City of Portland, Oregon
Bureau of Development Services
Land Use Services
FROM CONCEPT TO CONSTRUCTION

Memorandum

Date: August 14, 2024
To: Adjustment Committee
From: Don Kienholz, Senior City Planner, Land Use Services, PPD
RE: LU 23-107799 AD TIR appeal – Updated Finding for Adjustment #3

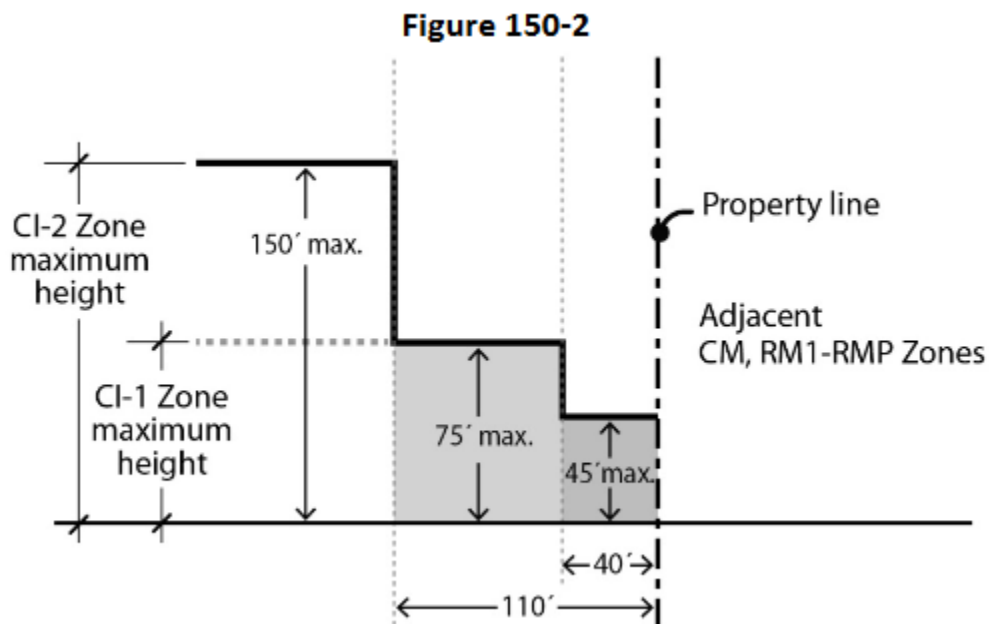
This adjustment is to increase the maximum building height from 45-ft to 50-ft for two small sections of the building that are within 40-ft of the lot line along SE 77th that is across from an RM1 zone **and for the south facing façade along SE Division St that is across from the RM2 zone.** This standard is intended to provide a stepdown in building height for sites across the street from multi-dwelling residential and commercial/mixed use zones as depicted in the figure below:

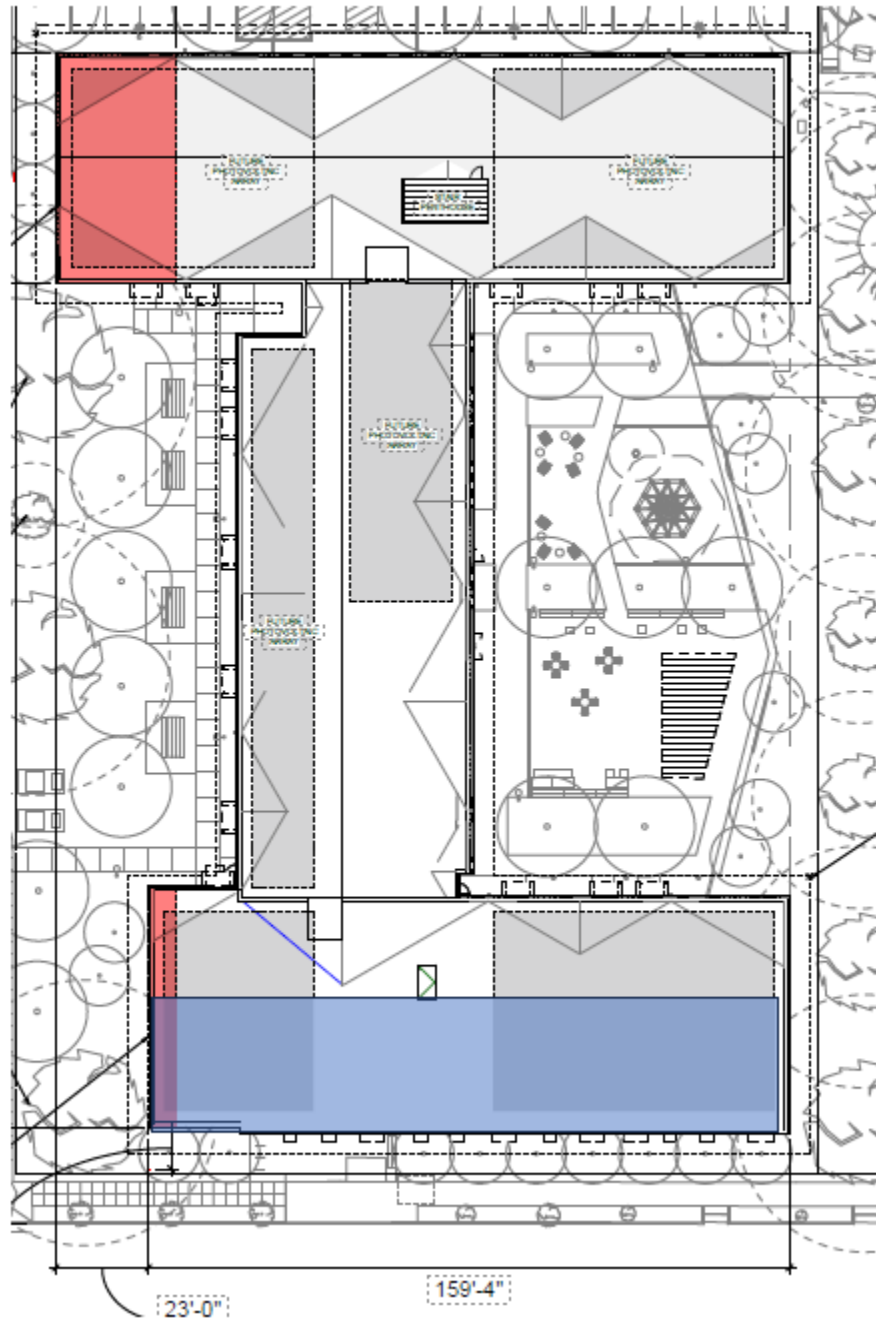
building will be 50-ft in height in the stepdown zone, 5-ft more than the base zone allows. The additional 5-ft in height allows for the addition of a full 4th floor in that segment of the building, which will include two, two-bedroom units. Likewise, on the south side of the property, the proposal includes an approximately 7-ft deep by 57-ft wide segment on the 'foot' of the I-shaped building at 50-ft in height instead of the maximum allowed 45-ft within the stepdown height area. A graphic depiction of the portions of the building in the stepdown zone is shown in red below:

The two sections of the building in the step down zone with the additional 5-ft of height account for only 114-ft of the building's nearly 267-ft façade along SE 77th Ave. The vast majority of the building will be entirely out of the stepdown area. The closest point of the building within the stepdown area to the nearest house, which is at the north end, would still be approximately 80-ft away from the house across SE 77th Ave. The closest point of the building in the stepdown area on the south end of the site would be approximately 100-ft from the closest home across SE 77th Ave. With the building being below the maximum building coverage for the whole site and the individual tax lot (if it were a standalone site), the building being below the allowed floor area and the building meeting the minimum setbacks, the proposal will reflect the general intent of the C12 zone.

The south facing façade of the proposed building subject to the height standard is shown in blue above. The building is proposed to measure 50-ft in total height, five more feet than allowed by right within the first 40-ft from the property line along SE Division St. due to the property across the street being zoned RM2.
